Town of Medley

Date:	July 26, 2014
Subject:	RFP for Construction of Interior Alterations to the Medley Municipal Services Facility (MMSF Police Department Expansion)
Solicitation Number:	RFP 2014-03
OCPDS Number:	PS-1301
Opening Date / Time:	July 29, 2014 at 2:00 PM (Changed by this Addendum to Thursday, July 31, 2014 at 2:00 PM)
ADDENDUM Number:	3

Addendum 3 does the following:

Date	
Scale	
Drawn	
Job	
Sheet	S-1
Of	Sheets

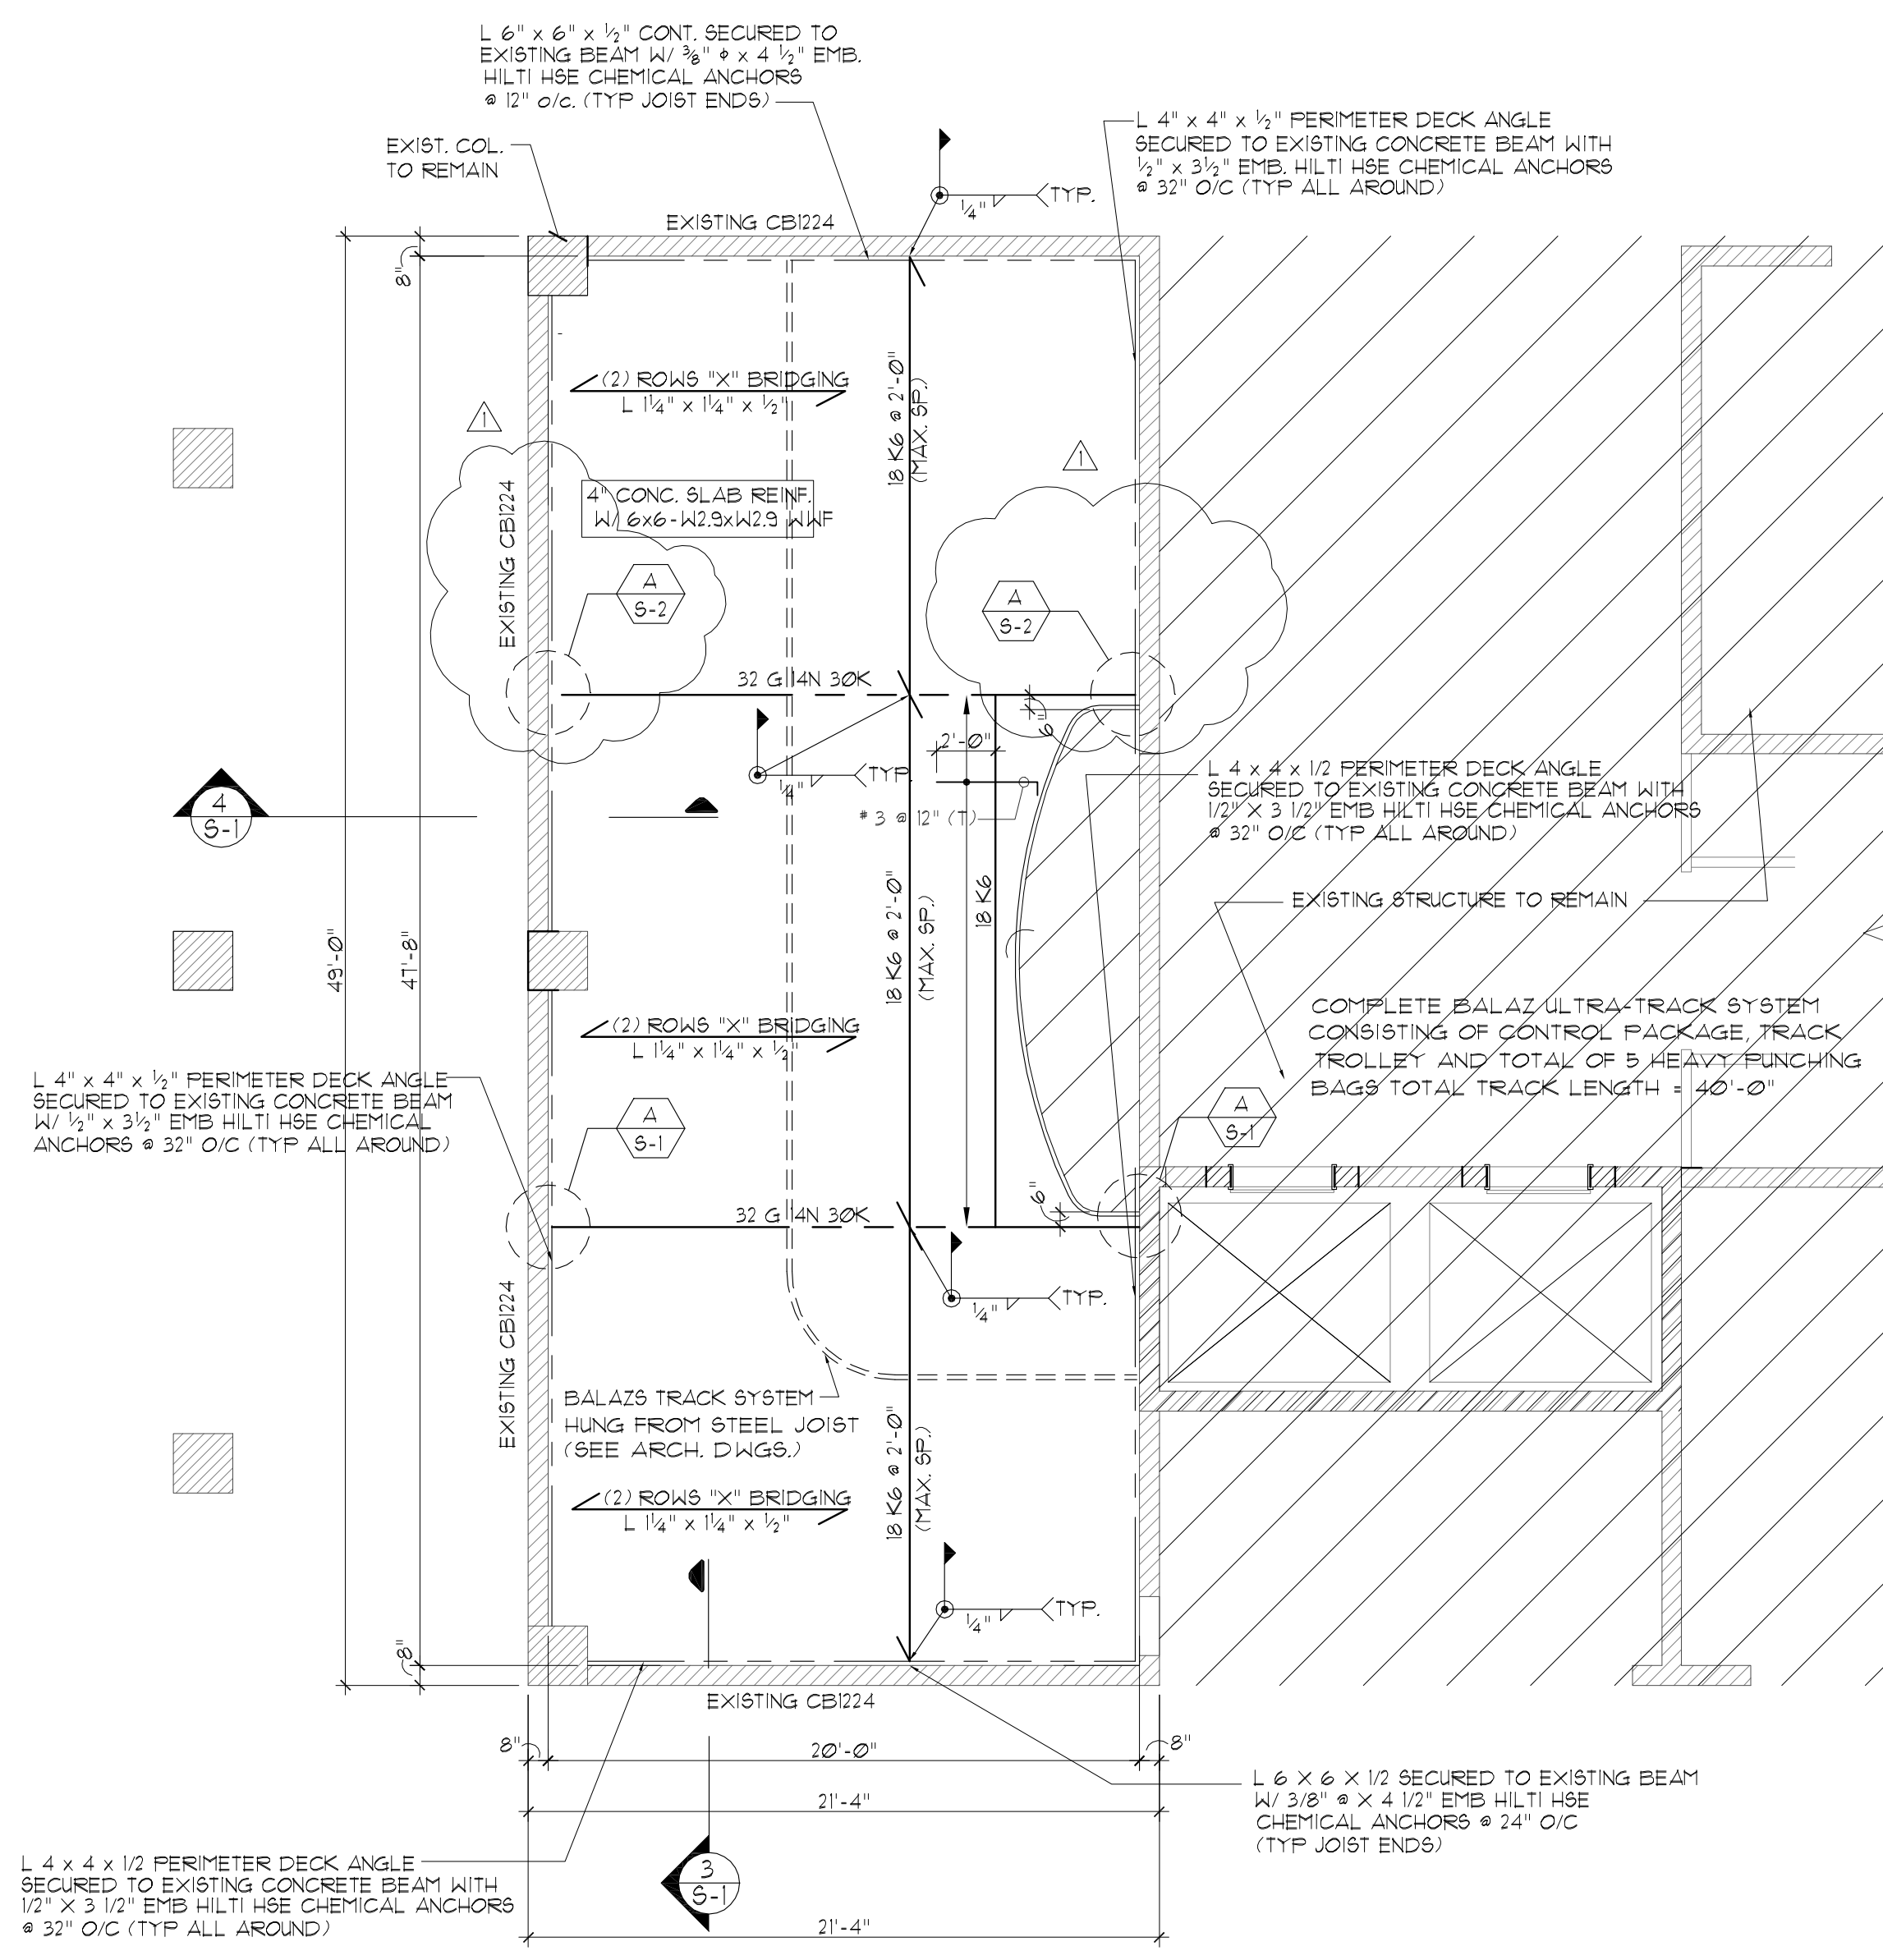
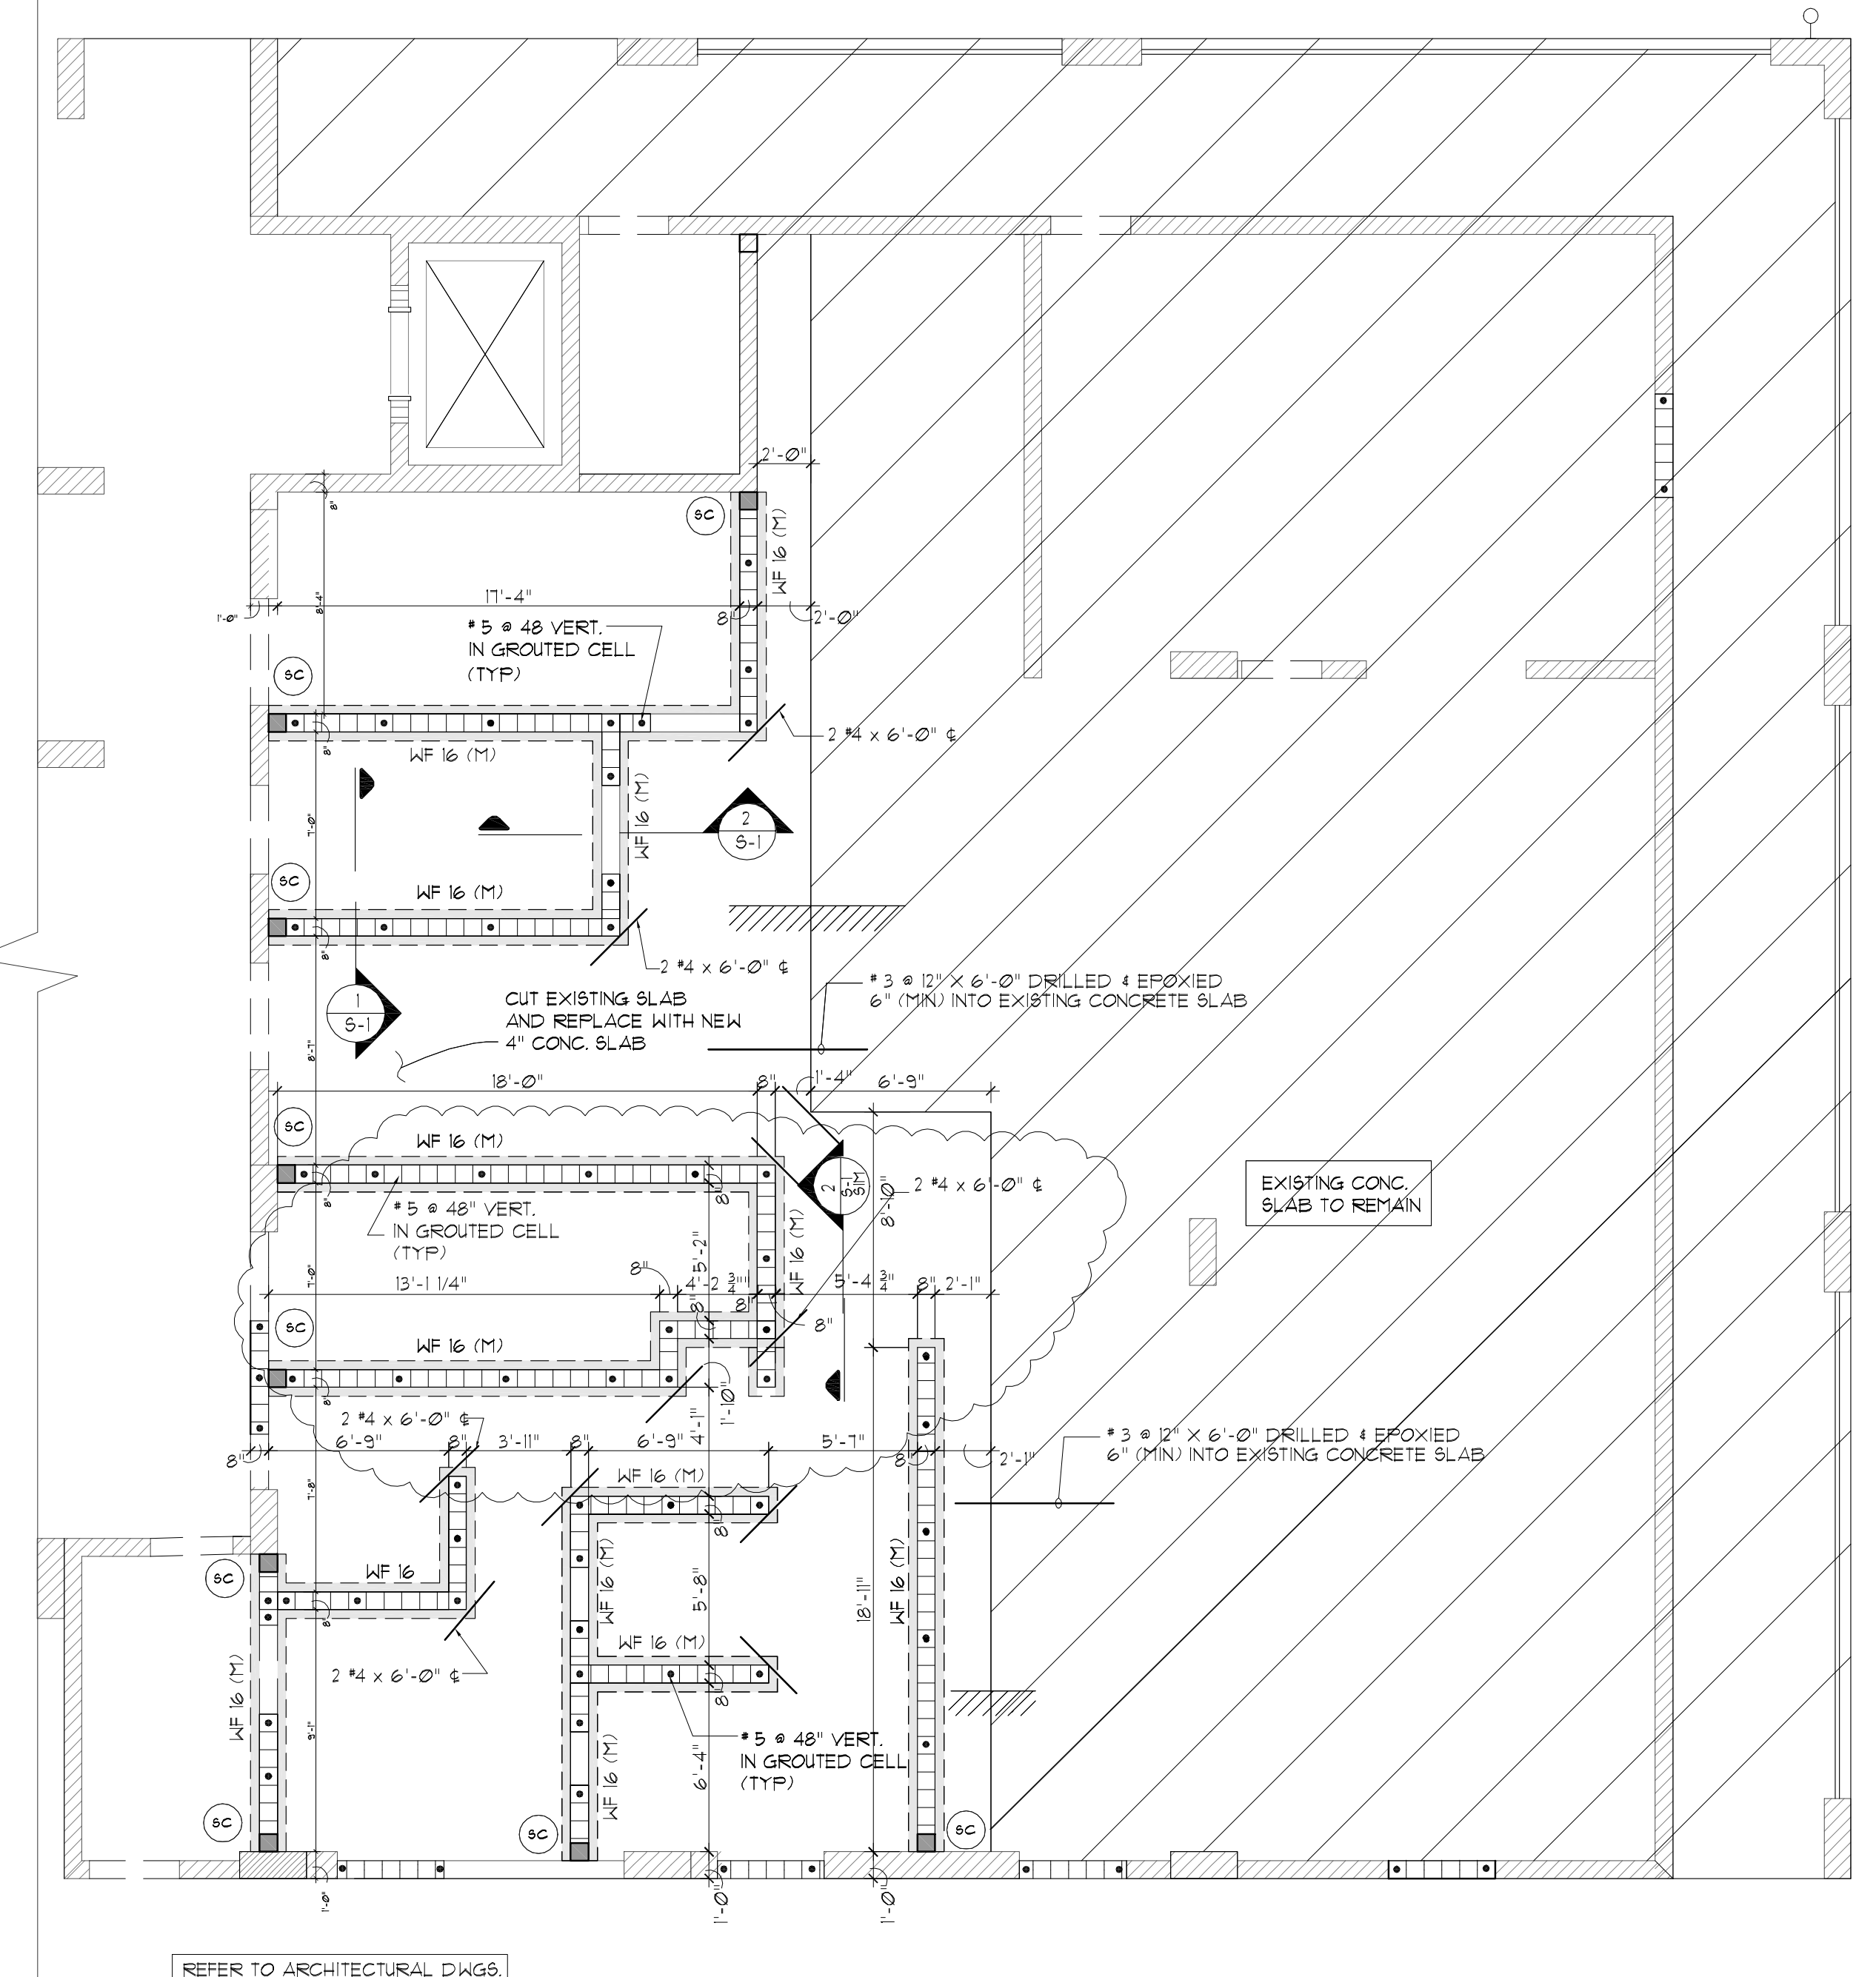
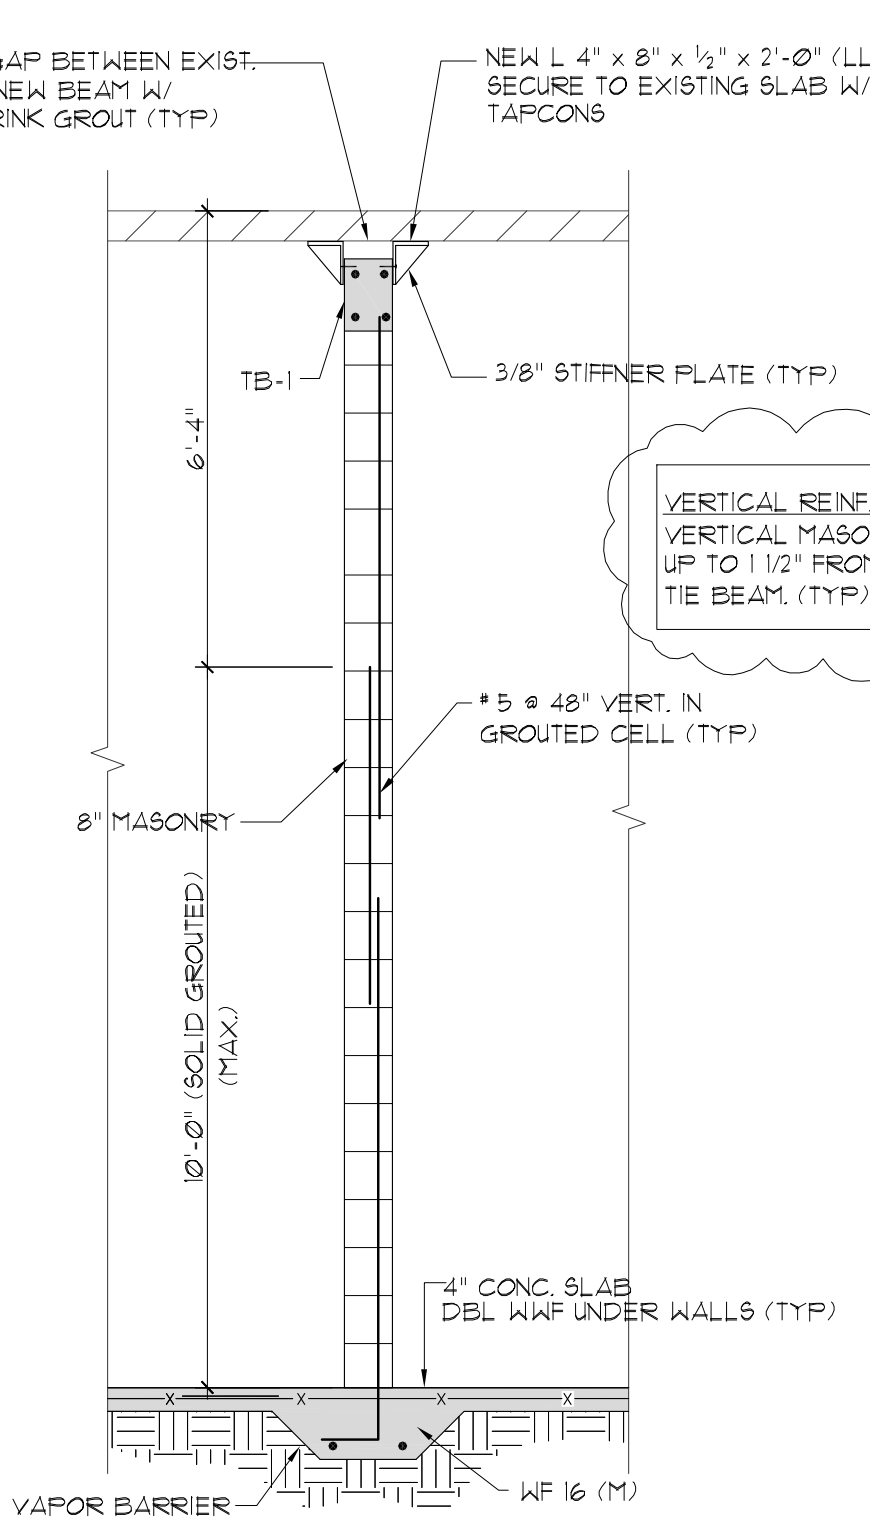
RFI No.	RFI Ref.	Question	Responses
A3-012	E-002	Provide location of security pool	Fire Alarm panel is located behind the elevator core. Access is through parking garage
A3-013	E-003	Lobby 118 calls for (3) fixtures on east part of room. Please clarify if new or existing	Lights are existing to remain
A3-014	E-004	Rooms 116, 117, 118 call for new fixtures tied to EM circuits. Are they night lights? Should they turn on with rest of fixtures? There is no relay shown	They are intended to be night lights
A3-015	B-005	There seem to be discrepancies between the structural and architectural drawings as follows;	Attached is revised Structural sheet S-1 addressing all discrepancies

1. The electric drinking fountain niche seems to be approximately 14" off	
		2. Structural does not shown on the CMU wall continue to form the drinking fountain niche

3. Structural does not indicate 2 beams and CMU walls	
A3-016	B-006	Is there a detailed Finished Hardware Schedule for this project? The hardware schedule found on A-16.1 is not accurate and complete. Hardware set SH02 are for Doors 03, 06. The problem is that door 06 is a pocket door while hardware set SH01CELL are for doors 04, 05 and door 04 is for holdings cell while door 05 is for the Men's Locker. Please advise...	Hardware type SH01 is for doors # 03 & 04, Hardware type SH02 is for doors # 01 & 02, Hardware type SH03 is for doors #1-A (two doors). Hardware type SH04 is for door #1-B. The plans call for the Contractor to match the existing doors and hardware and to submit a complete schedule hardware schedule for the balance of the doors (doors #5 thru #26)
A3-017	E-005	Can you please provide specifications for the Epoxy Flooring and Wall Covering noted on the Finish Schedule? We have similar products but would like to confirm performance specifications meet the designed product	Attached are the specifications for the Armor-Glaze system by Vanberg. The plans call for the Armor-Glaze for the walls and the Armor-Slate for the floor

1. In Section 1 - Notice to Proposers:
 - a. In the first paragraph the submittal date for the proposal has been changed to **July 31, 2014 at 2:00 PM.**
2. Provides responses to additional Request for Information (RFI’s) submitted for the Project and issued to date.
3. Provides revised Structural drawing Sheet S-1 in response to RFI A3-015.
4. Provides technical specifications for the Vanberg Armor-Glaze system in response to RFI A3-017.
